I have received a letter from the Tasmanian Planning Commission regarding the Draft Amendment to the Clarence City Council's Local Provision Schedule - PDPSAMEND-2021-022808. The letter confirms receipt of information by Gray Planning (acting on behalf of Airlines of Tasmania) and advises that a hearing will be held. It is my understanding that the hearing has been scheduled for 5 October 2023.

Residual Height

Proposed Airport Obstacle Limitation Area Overlay

Figure A: Extract from Cambridge Residual Height Detailed Map-East

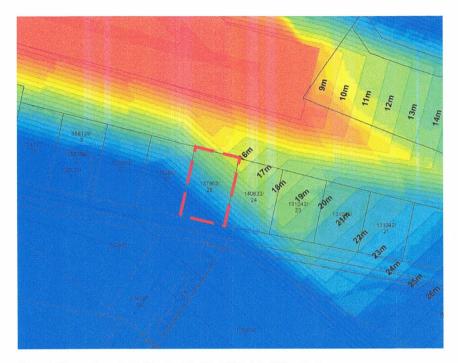
It is not entirely clear what 'residual height' refers to in the submitted mapping. On Figure A below I have pasted part of the residual height map, as it relates to this property, and the legend to the original image.

This property (identified as 137962/25) is mapped as pale yellow to medium blue, which therefore means that, according to the mapping, the applicable Residual Height on my property ranges between about 7m and 17m. However, to my knowledge my property has an AHD of approximately 8-8.5m.

In the table provided within the Gray Planning submission (cropped below), this property is then listed with a min residual height of 7.05 and a max residual height of 22.07. This differs from the Cambridge Residual Height Detailed Map-East. My site does not have a significant slope, which suggest that the data may be incorrect. Alternatively the maximum 22.07 may mean the site level plus existing structures, however again this is not made clear.

Figure B: Extract from Cambridge Airport Obstacle Limitation Area map

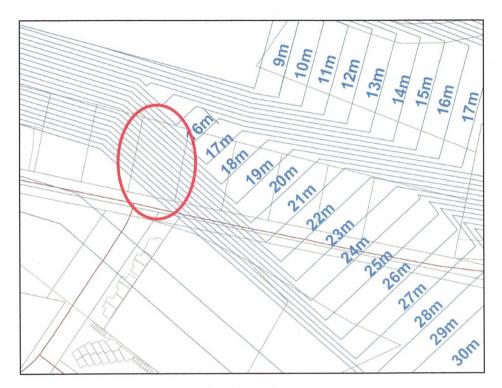
The mapped proposed Airport Obstacle Limitation Area is shown between 16m AHD and 30m AHD.

The Light Industry Zone allows for a building height of not more than 10m. If the minimum residual height of 16m is taken from the existing ground level, then any proposed building that complies with the 10m building height expected for this site, would conflict with the proposed overlay.
